## **ADDENDUM No. 1**

### **Valley of the Moon Nursery School ADA and Maintenance Improvements Project**

**June 23, 2016**

SHEET C100  
EXHIBIT 2 OF 3

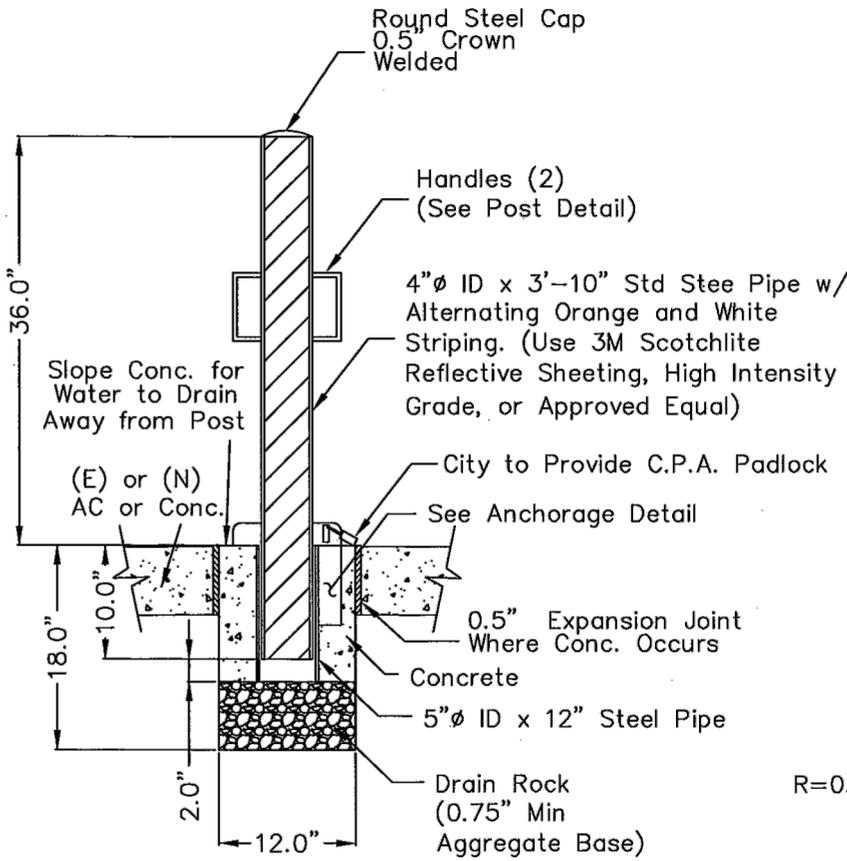
- ARCHITECTURAL SKETCH (ASK) NO.1.1 (8 ½ x 11)      Modifies SHEET C100
- ARCHITECTURAL SKETCH (ASK) NO.1.2 (8 ½ x 11)      Modifies SHEET C100
- ARCHITECTURAL SKETCH (ASK) NO.2 (8 ½ x 11)      Modifies SHEET C200

REVISION:  
ADDENDUM NO. 1  
SCALE: AS NOTED  
DATE: 06.23.2016  
PAGE:  
C100  
DRAWING:  
ASK 1.2

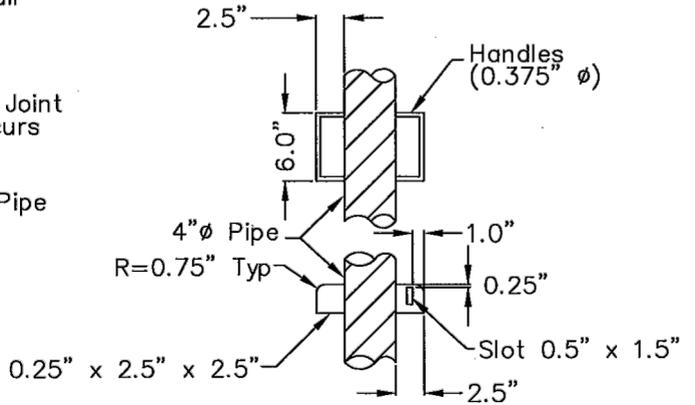
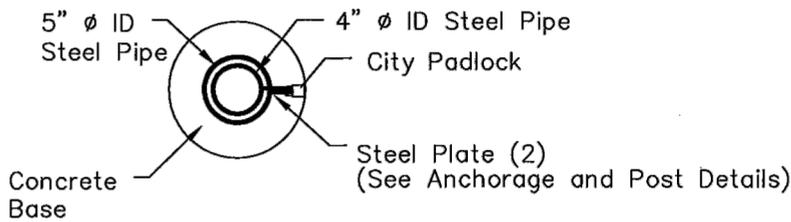
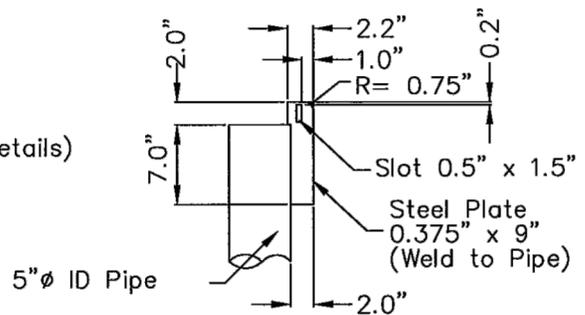
**NOTE:**  
ALL STEEL TO BE  
GALVANIZED
